TRANS/WP.29/696

Working Party on the Construction of Vehicles

DRAFT SUPPLEMENT 3 TO THE 03 SERIES OF AMENDMENTS
TO REGULATION No. 36

(Public service vehicles)

Figure 11

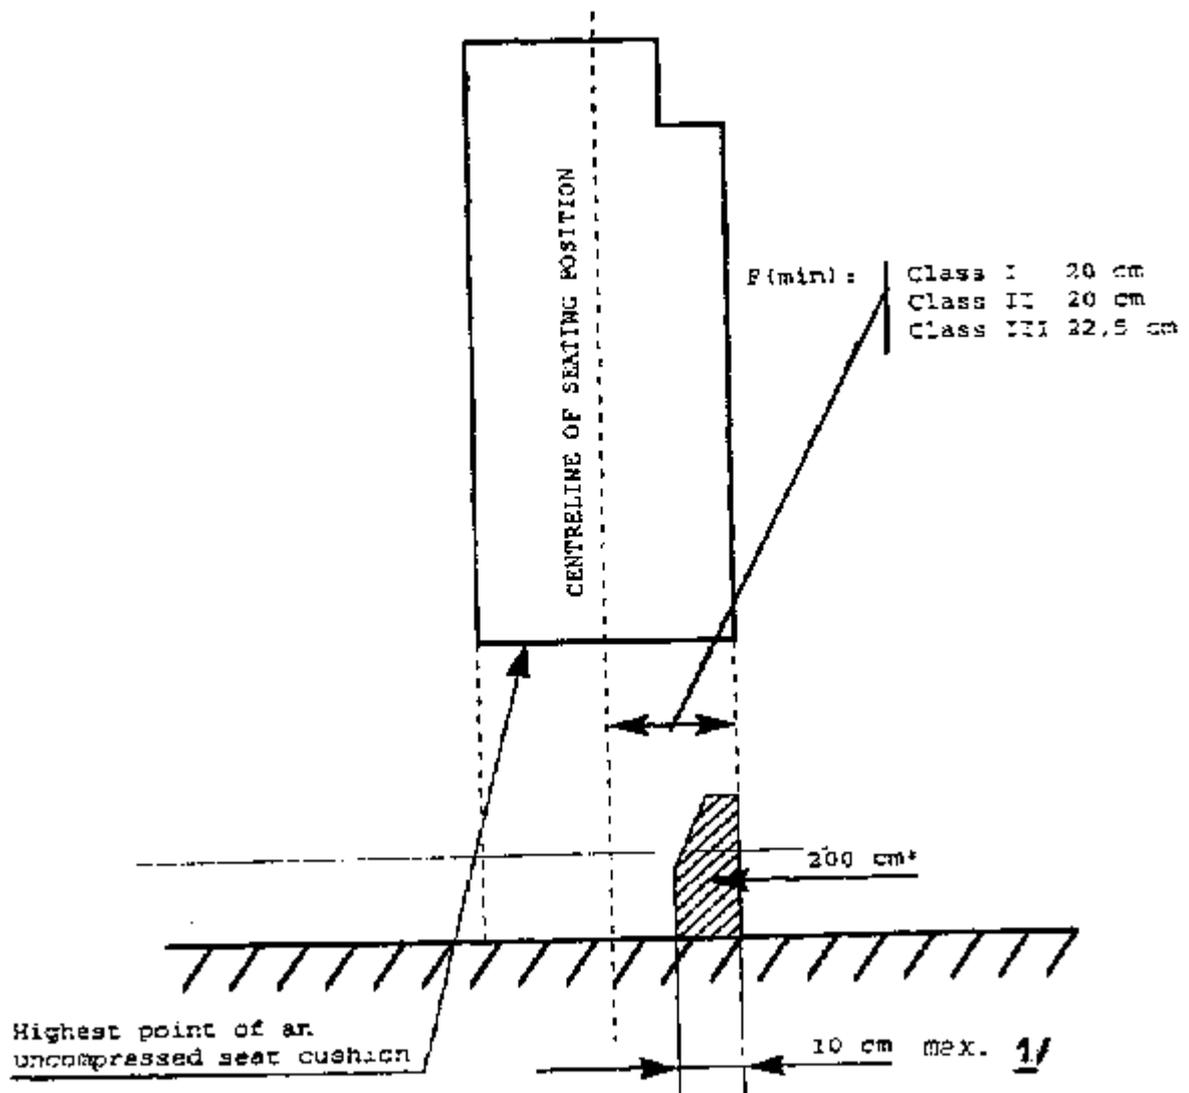
Annex 3, figure 11, replace by the following figure:

PERMITTED INTRUSION OF A CONDUIT

(see paragraph 5.7.8.6.2.3)
